| <b>DESCRIPTIVE REPORT</b>   |                  |
| <b>"HOBE SOUND"</b>   |                  |
| Field No.   | T-8413           |

Division of Photogrammetry  
Review Report of  
Topographic Map Manuscript T-8413

PHOTOGRAPH AND CONTROL SKETCH OF PLOT 312A (PARTIAL)

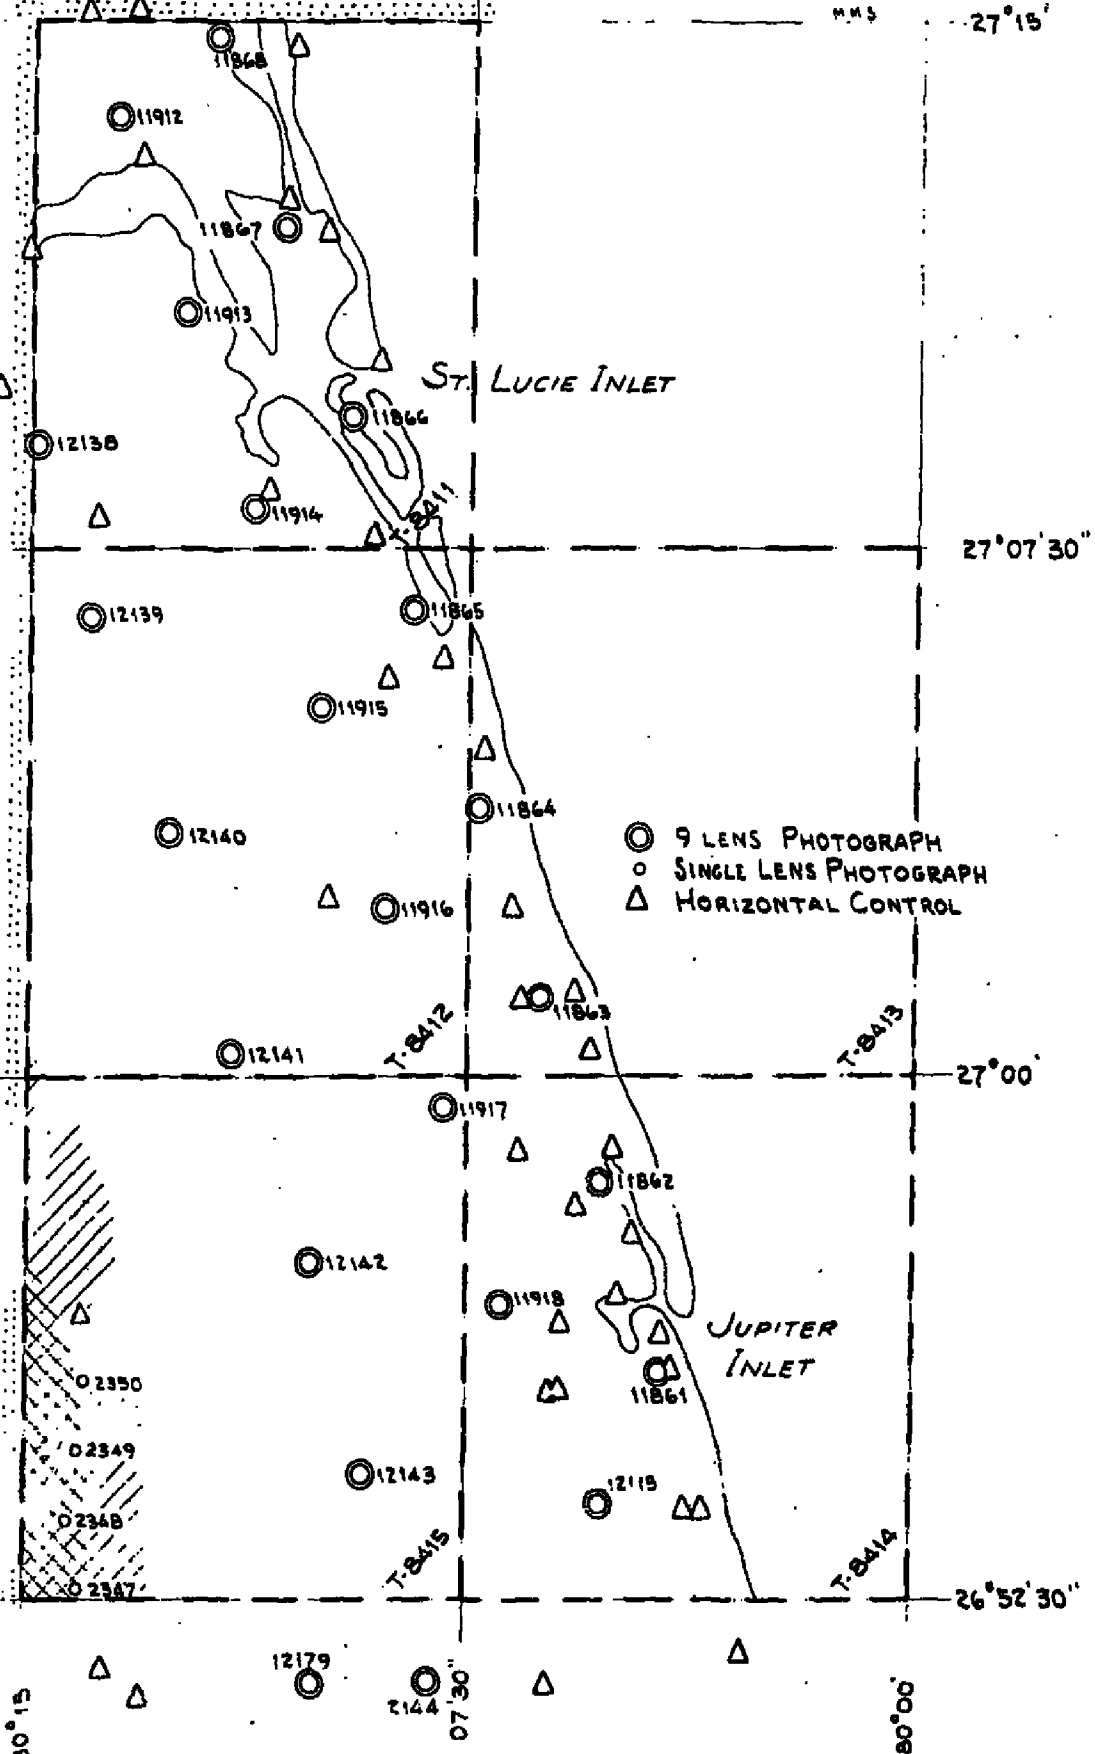
As shown in the accompanying sketch the control recovered and used is considered sufficient to control the main radial plot. In areas with abundant control some of the triangulation was not transferred to the base grid and the intersections of cuts for these stations coincided satisfactorily with the plotted positions.

In one portion of the plot, the south west area of T-8412, it would have been desirable to have a control station. By recovering and pricking ALLEN 1934, and using photographs 16398 and 16399 it is felt that a satisfactory plot was achieved without the cost of traverse for additional control.

One control station, SUBSTITUTE STATION SNAKE 1930, was not used in the plot. The character of the mangrove as shown on the 1942 nine lens photograph on which the station was pricked in August 1944 underwent such a radical change as shown on the March 1945 single lens photographs as to cast considerable doubt on the identification of the station. Because sufficient control had been recovered in the area the station was not used.

With the exception of the western portion of T-8415 photograph coverage for this plot was good. In the western portion of T-8415, cross hatched area in accompanying sketch, photograph coverage at best gave two cut intersections for pass points. Along the project limits, double cross hatched in the sketch, there is an area whose photographic coverage for the radial plot is considered of reconnaissance order only.
